# ACCESS PLANNING REVIEW REPORT

PROJECT: **Lang Walker AO Medical Research Centre - Macarthur**  
STAGE: **SSDA**  
PROJECT NO: **GDL 210276**  
PREPARED FOR: **BVN Architects**  
DATE: **14.10.2021**

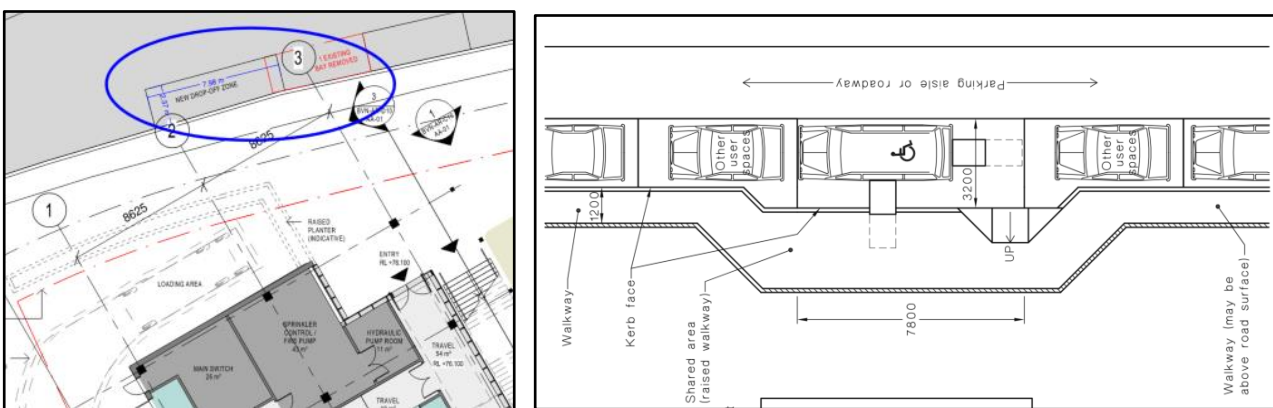
The development includes a proposed new drop-off zone on Parkside Crescent public footpath that is in close proximity to the new main entry 1.

The following access non-compliances / access issues have been identified:

Recommended Action: Provide a AS1428.1 kerb ramp at rear of drop off zone with at least 1500mm min. length landing space at top of kerb ramp (for 90 degree turning) on footpath. The drop off- zone to be developed to meet the intent of parallel accessible car-parking space spatial design requirements of AS2890.6:2009 Fig 2.6 (BCA referenced standard for on-site accessible parking) and AS2890.5:2020 (Advisory/non-referenced on-street parking standard) as far as possible.

NOTE: 3.2 M min. width accessible parking/drop-off space allows for use of driver side hoist installation (for either passenger or a driver), however due to existing road/footpath design, this increased width may not be achievable – To be confirmed.
